Section 38.3.3

August 2015 Presentation Meeting

Section 38.3.3 Proposal for change

Tests T1 to T5 Flow:

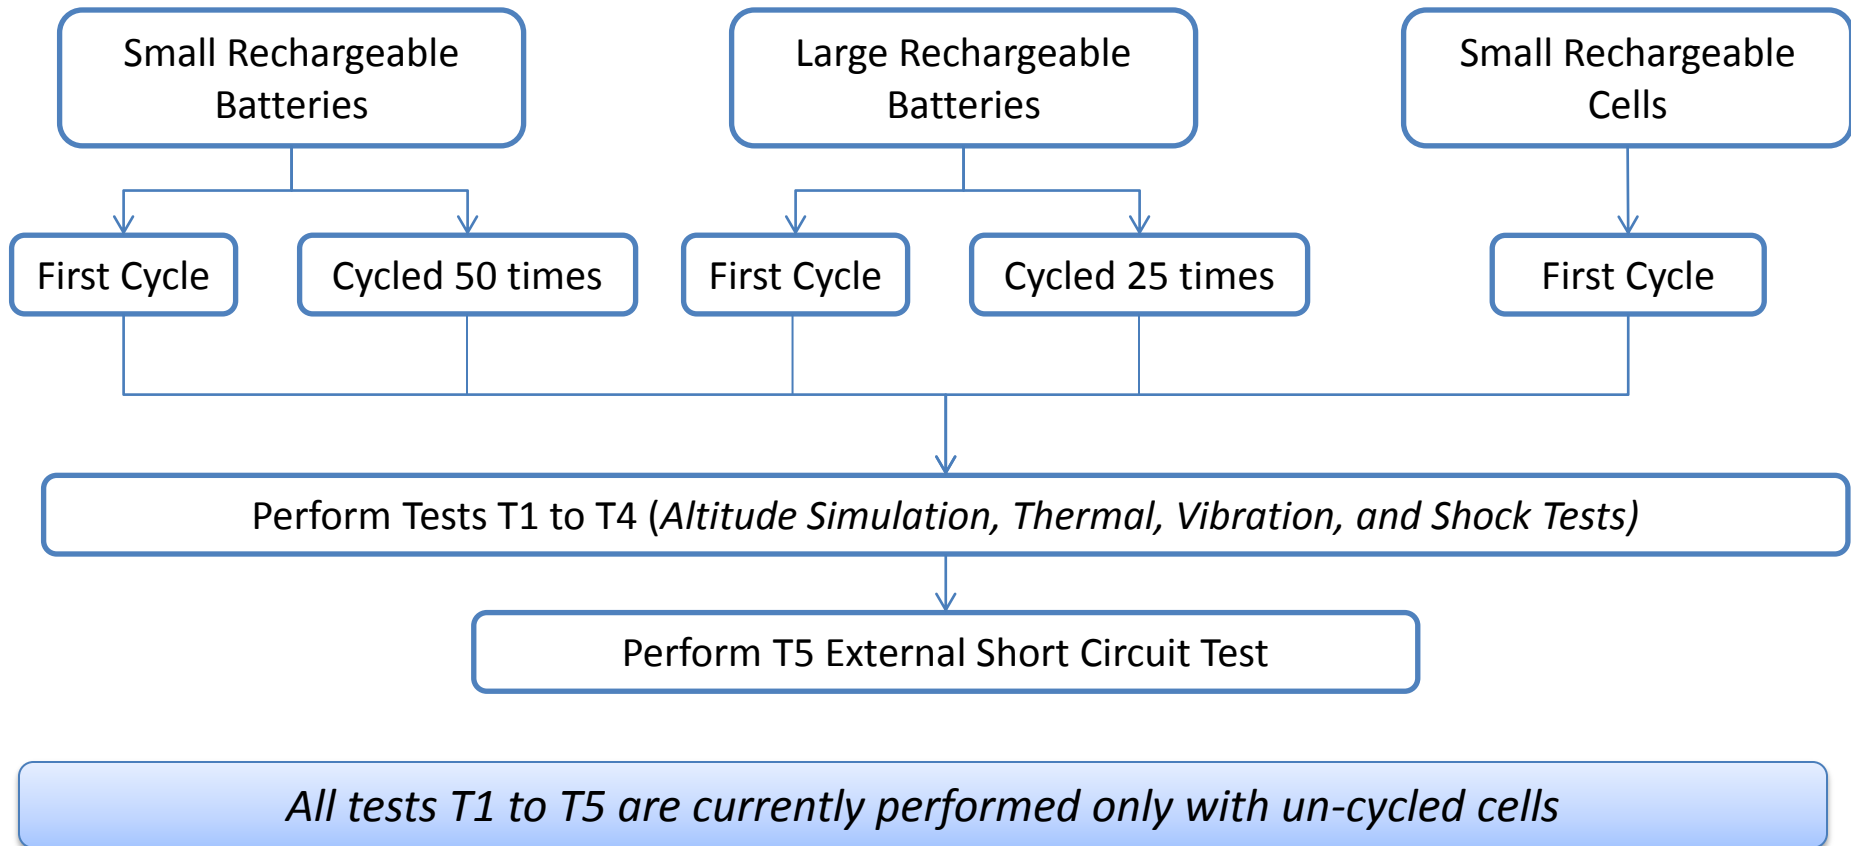
Add Cell Cycling:

- Detect cell anomaly (such as Lithium plating, activation of cell internal safety device) prior to the battery testing
- Harmonize with IEEE1725 standard cell test section 5.6.6 “**Evaluation of Excess Lithium Plating and Short-Circuit Test on Cycled Cells**”
- Allow cells to be cycled at maximum continuous current rates specified by manufacturers. Battery rates may be limited based on safety electrical circuit limits
- Cell cycling does not prolong test cycle time and is no longer than existing test flow (i.e. same time as T8 Forced Discharge)
- Change cycling requirements to 25 cycles from 50 cycles
 - Number of 25 cycles aligns with large batteries requirements section 38.3.3
 - Harmonize with IEEE1725 standard CELL test section 5.6.6 “Evaluation of excess lithium plating”
 - Cells at 25 cycles have more energy than 50 cycles

Energy Comparison – Prismatic Cell

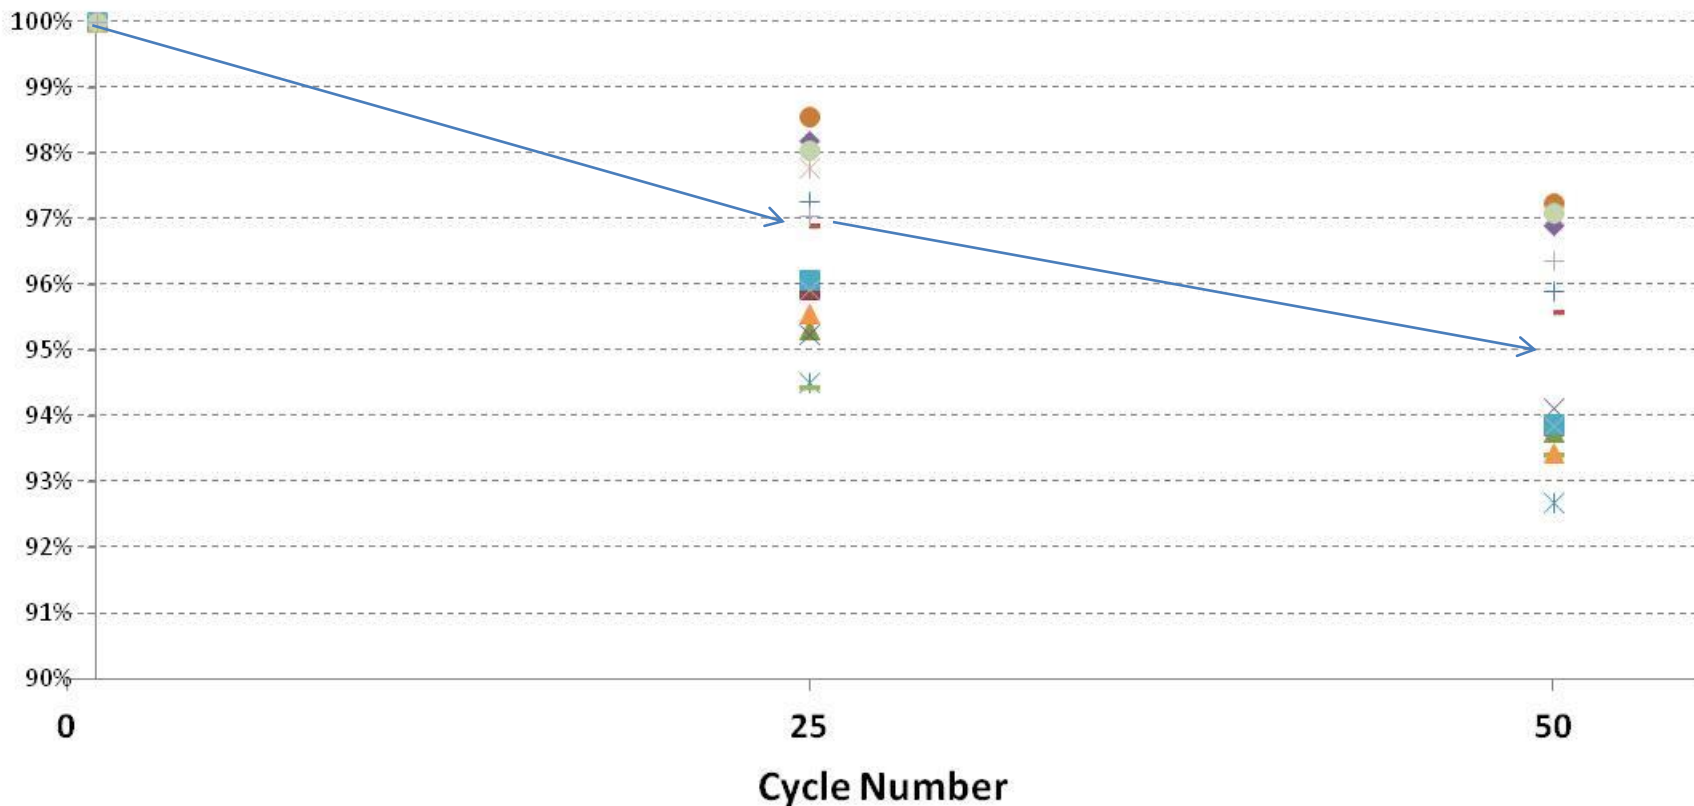
Cell Energy Fresh > @ 25 Cycles > @ 50 Cycles

Energy Comparison – Cylindrical Cell

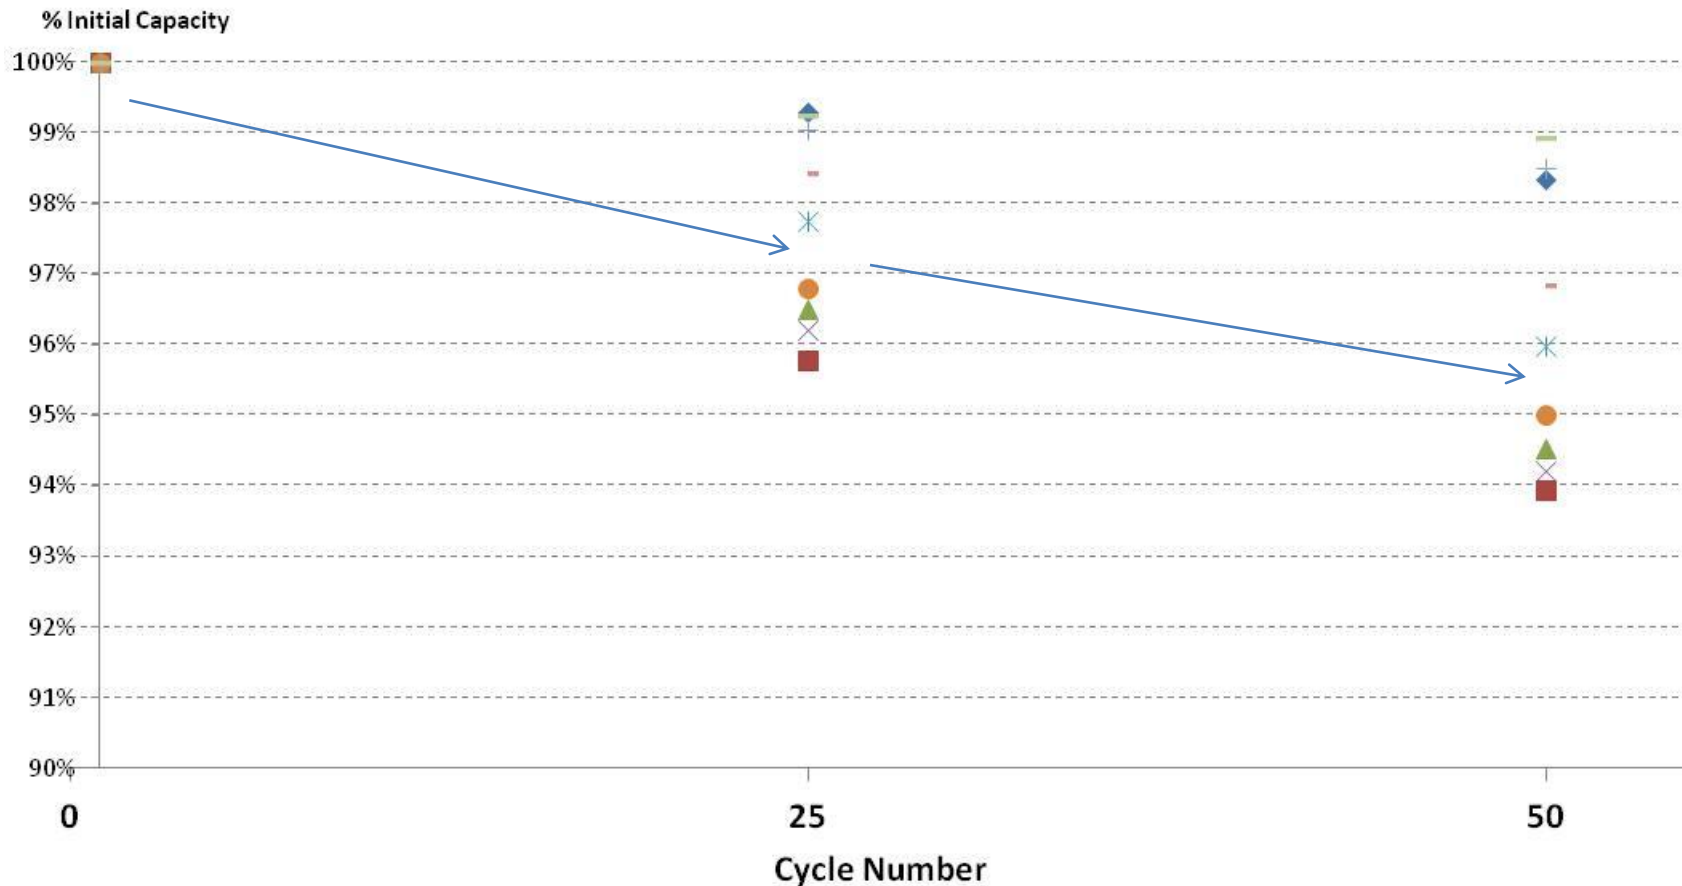
Cell Energy Fresh > @ 25 Cycles > @ 50 Cycles

Component Cell External Electrical Short T5 Test Procedure

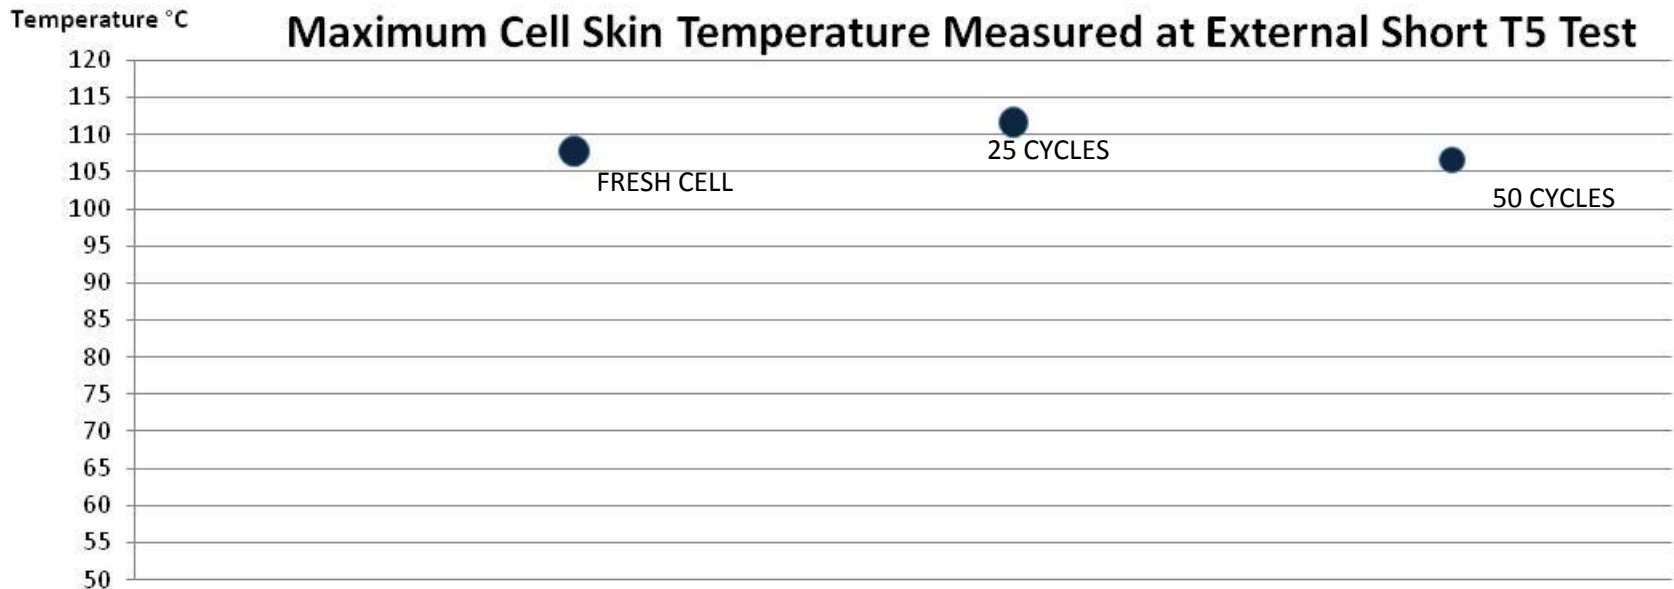
- Fresh cell
- 25 Cycles - NOT TESTED TODAY
- 50 Cycles - NOT TESTED TODAY

No significant temperature difference

25 Cycles cell temperature shows slightly higher than fresh and 50 cycles temperature
